MIL-F-63230 (AR)
AMENDMENT 3
26 APRIL 1984
SUPERSEDING
AMENDMENT 2
8 September 1983

MILITARY SPECIFICATION

FUZE, PIBD, XM740, SECOND ENVIRONMENT SENSOR FOR

This amendment forms a part of Military Specification MIL-F-63230 (AR) dated 17 August 1979, and is approved for use by the U.S. Army Armament, Munitions and Chemical Command and is available for use by all Departments and Agencies of the Department of Defense.

Figure 1 - Direction of Applied Acceleration

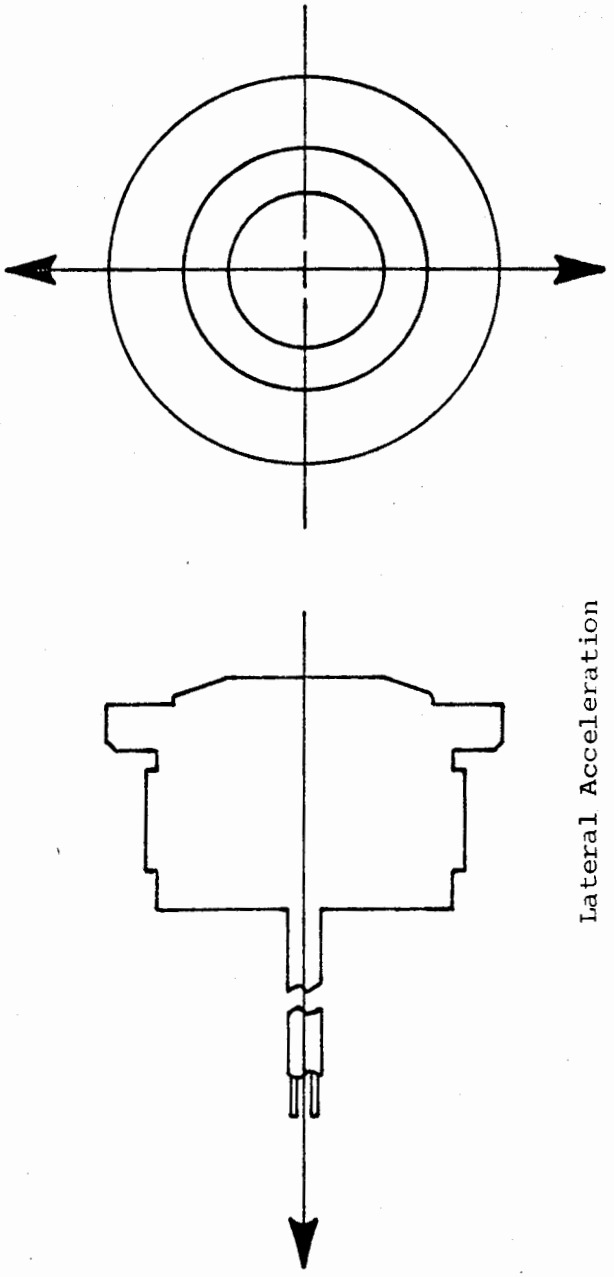
3.2.2.3, line 3: Delete "direction of acceleration" and substitute "The direction of the applied acceleration."

Figure 1: Delete in its entirety and substitute the attached Figure 1.

3.2.2.8, line 1: In title delete "Axial" and substitute "Lateral".

4.5.7.9, line 1: In title, delete "Axial" and substitute "Lateral".
